ENGINEERING CHANGE NOTICE

1. ECN ~~131551~~
Proj. W-016-75
ECN

Document Numbers Affected:
Construction Specification W-016H-C3, Rev. 2
Drawing H-2-80895, SH 3 of 3, Rev. 0

D. Section 15500, Revise paragraph 2.2.5 as follows:

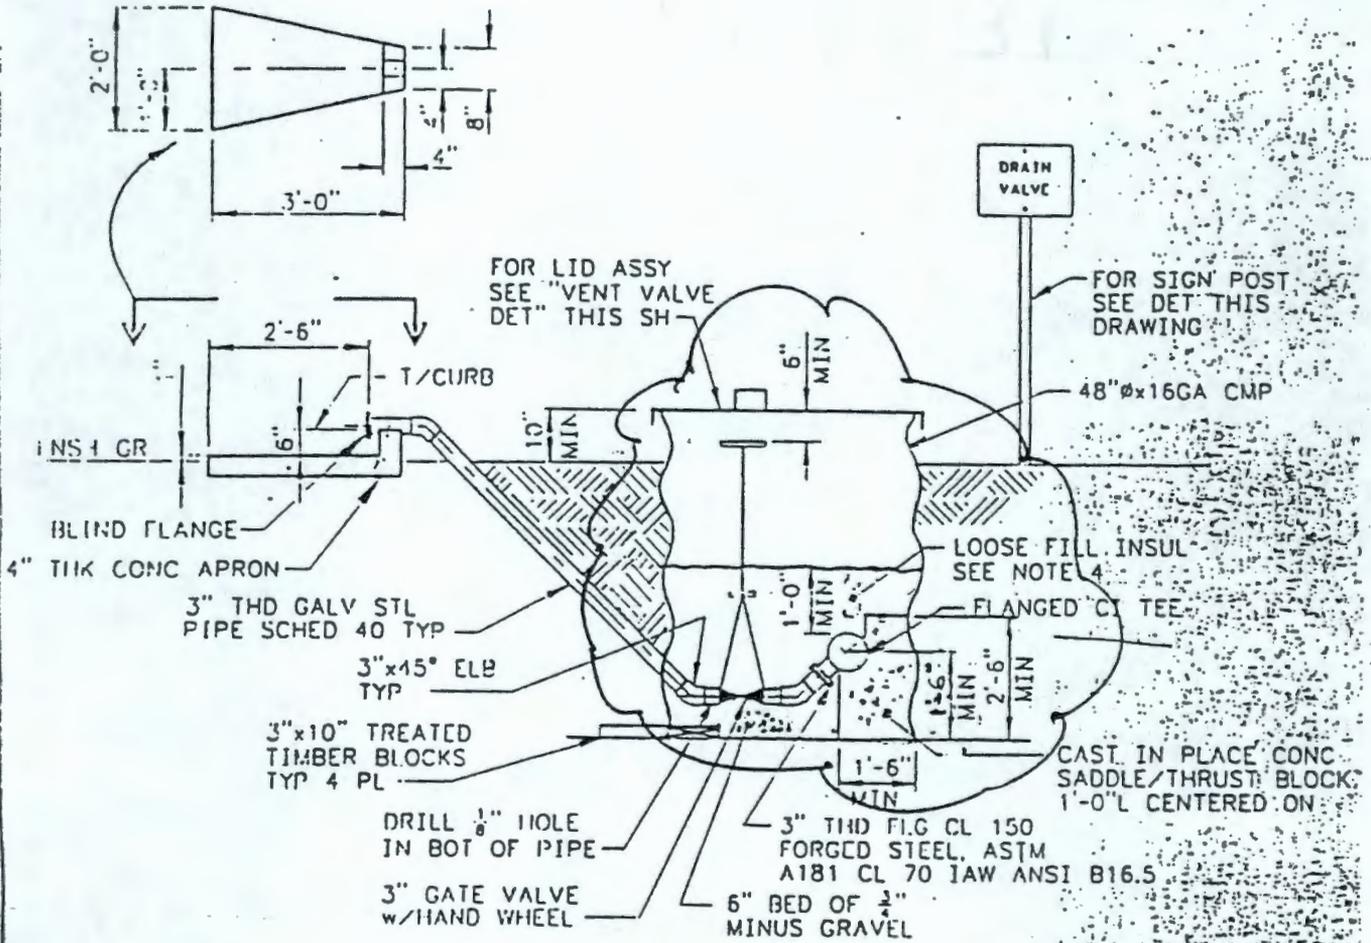
40 percent ASHRAE - Rated Filters: Initial minimum average filtering efficiency of 40 to 45 percent, when tested in accordance with ASHRAE 52, having UL Class II listing. Size 24 - by - 24 inch by thickness as required to achieve filtering efficiency. Filters to be complete with steel holding frames and retainers.
